OVERLAY DESCRIPTION

APPLICATION + INTENT

FIGURE 3.1 SETBACK REGULATION DIAGRAM

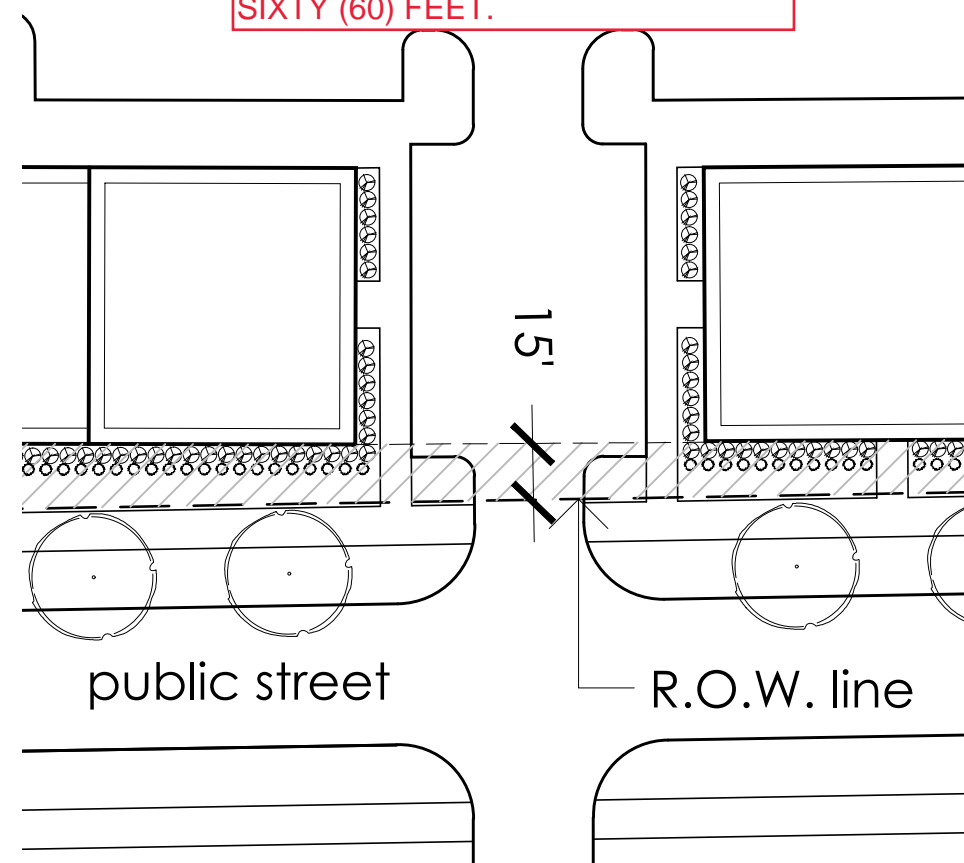
~~15 feet~~ ← 15-FEET, OR ZERO (0) FEET IF AN INTERNAL PROPERTY LINE THAT IS PART OF A PLANNED DEVELOPMENT.

~~20 feet, or zero (0) feet if an internal property line that is part of a planned development~~ ← 20-FEET

~~50 feet, or zero (0) feet if an internal property line that is part of a planned development~~ ← 35-FEET

ADD:
ACCESSORY STRUCTURE SETBACK:
NOT PERMITTED WITHIN THE FRONT YARD AREA.
SIDE AND REAR YARD SETBACK 5-FEET, OR ZERO (0) FEET IF AN INTERNAL PROPERTY LINE THAT IS PART OF A PLANNED DEVELOPMENT.

ADD:
ACCESSORY STRUCTURE SIZE:
MAXIMUM OF TWENTY (20) FEET IN HEIGHT AND NO GREATER THAN 2,500 SQUARE FEET.

FIGURE 3.8 PARKING LOT LAYOUT DIAGRAM

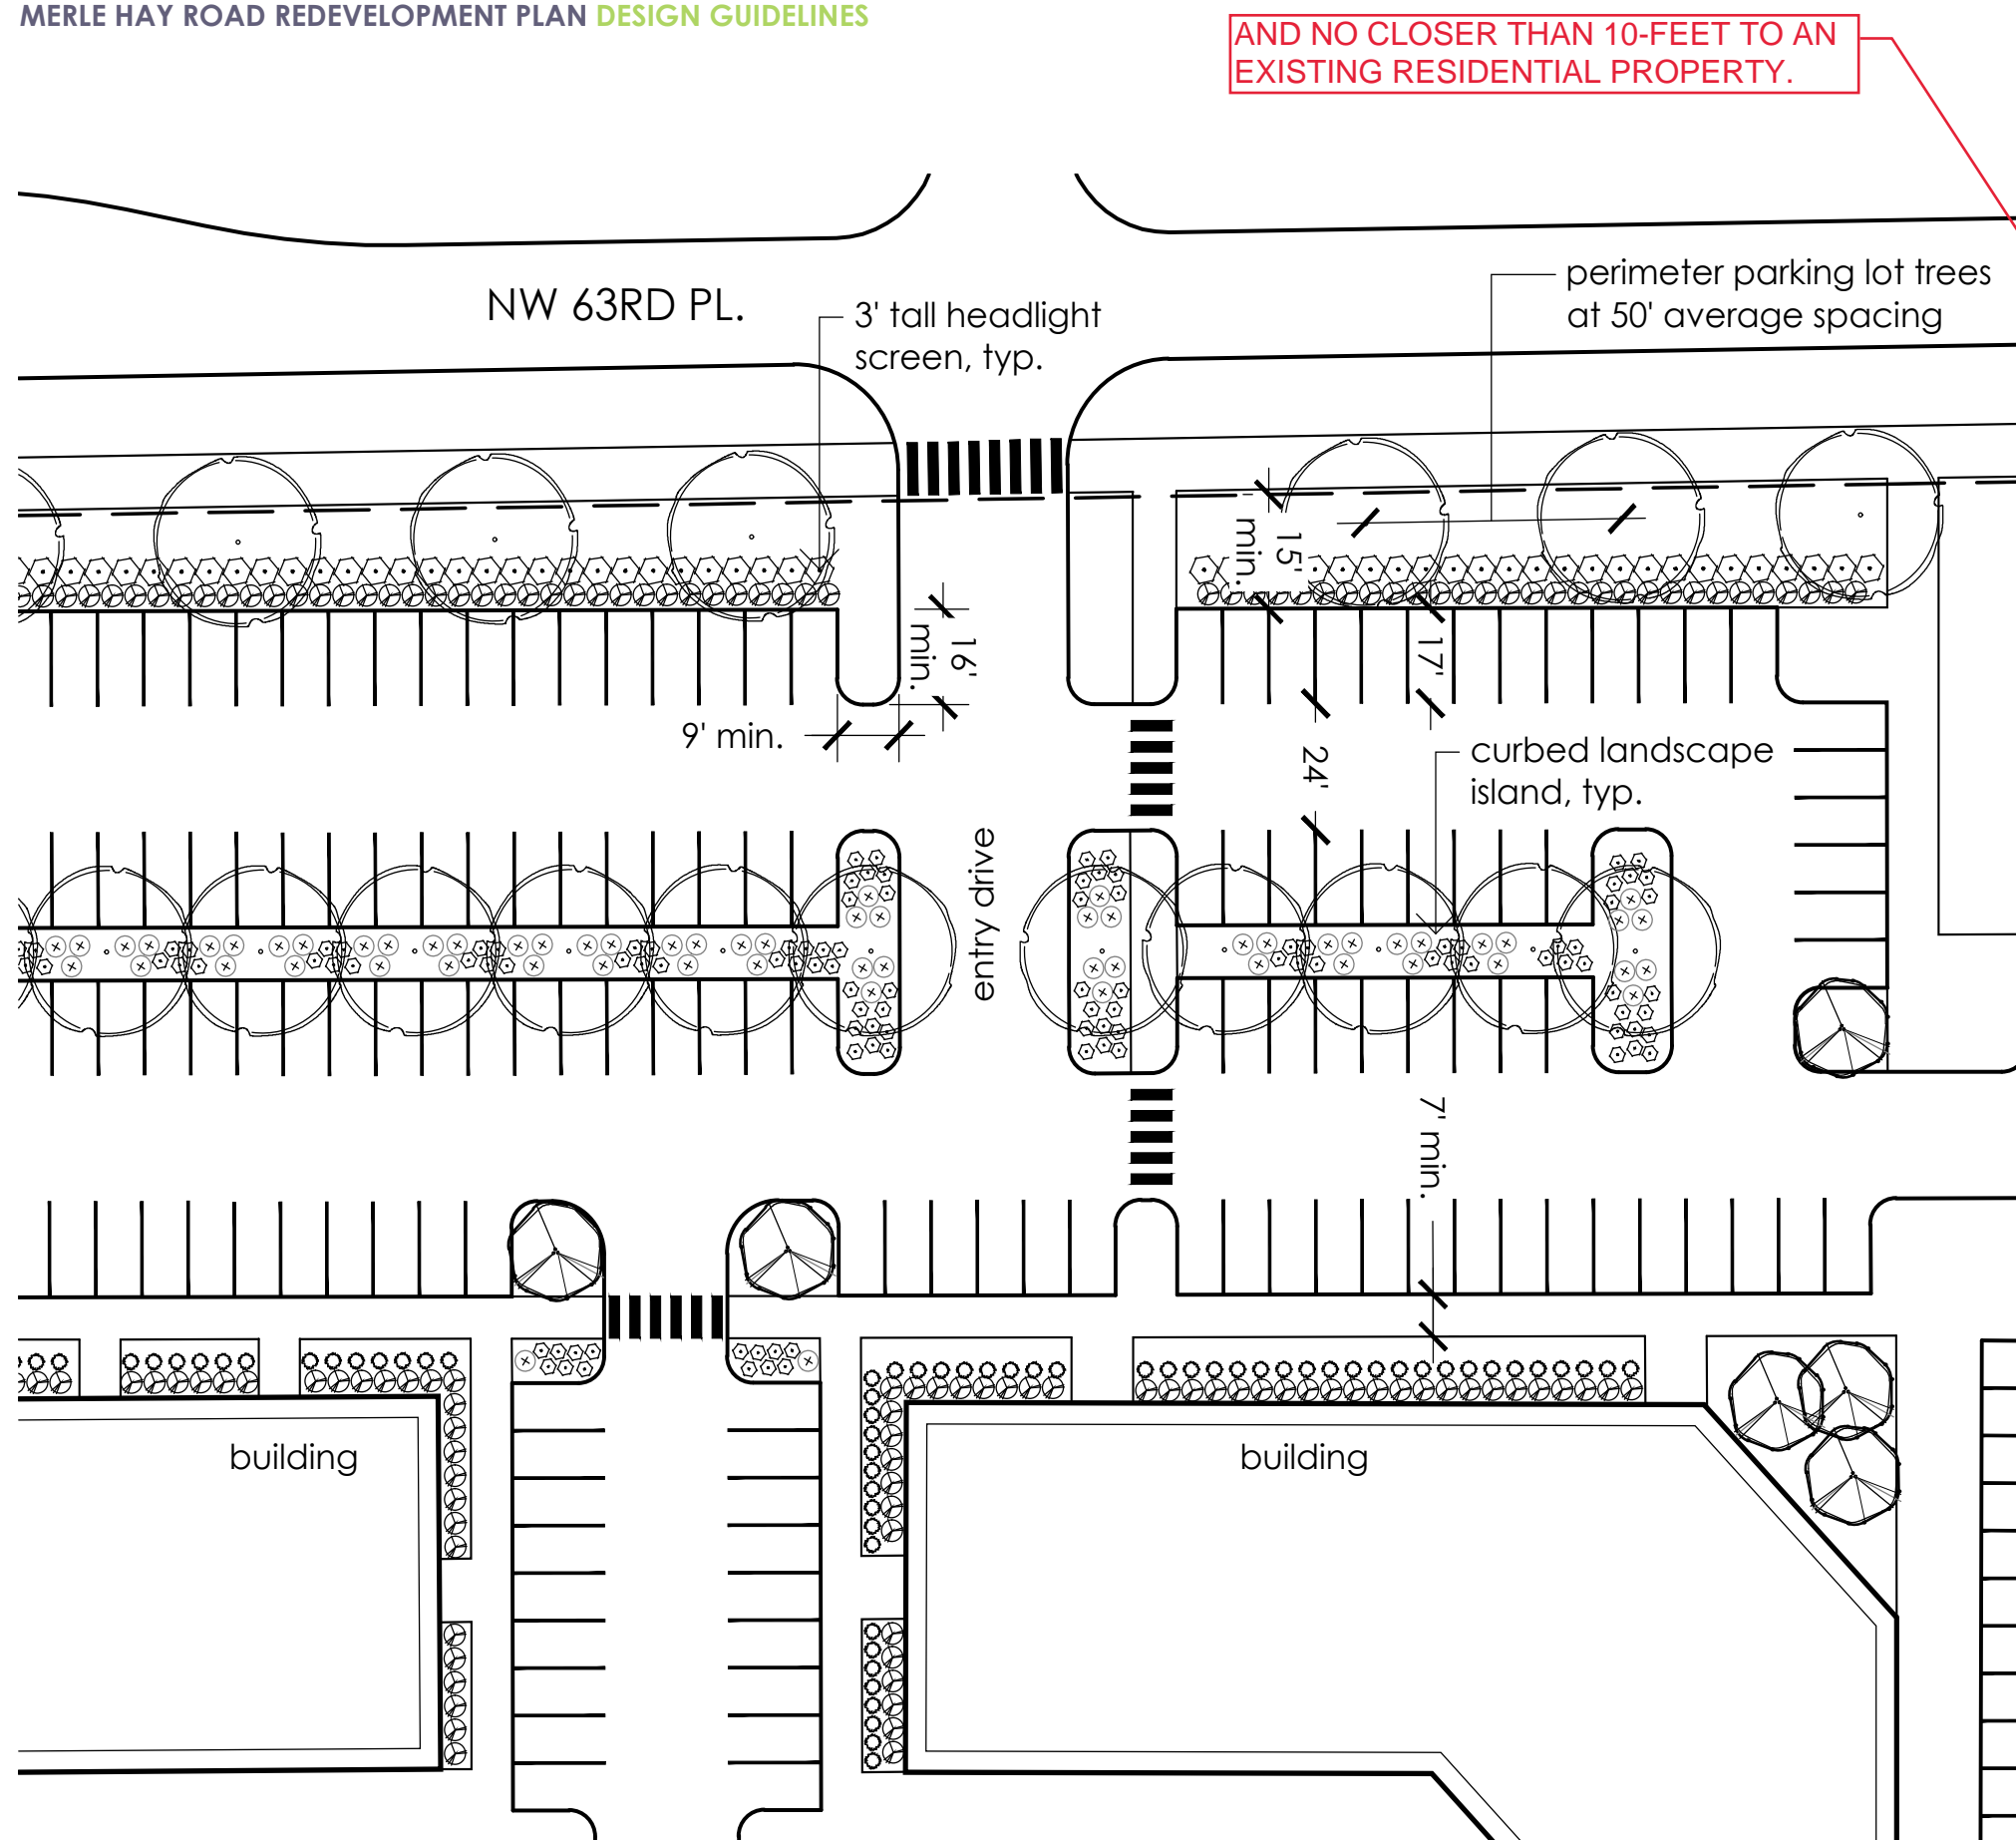
60 FEET

No off-street parking or loading area shall be more than ~~50 feet~~ from an overstory tree located within a landscaped open space area.

ADD "NON-PARALLEL"

← ADD "NOT IMPEDED BY SIDEWALK"
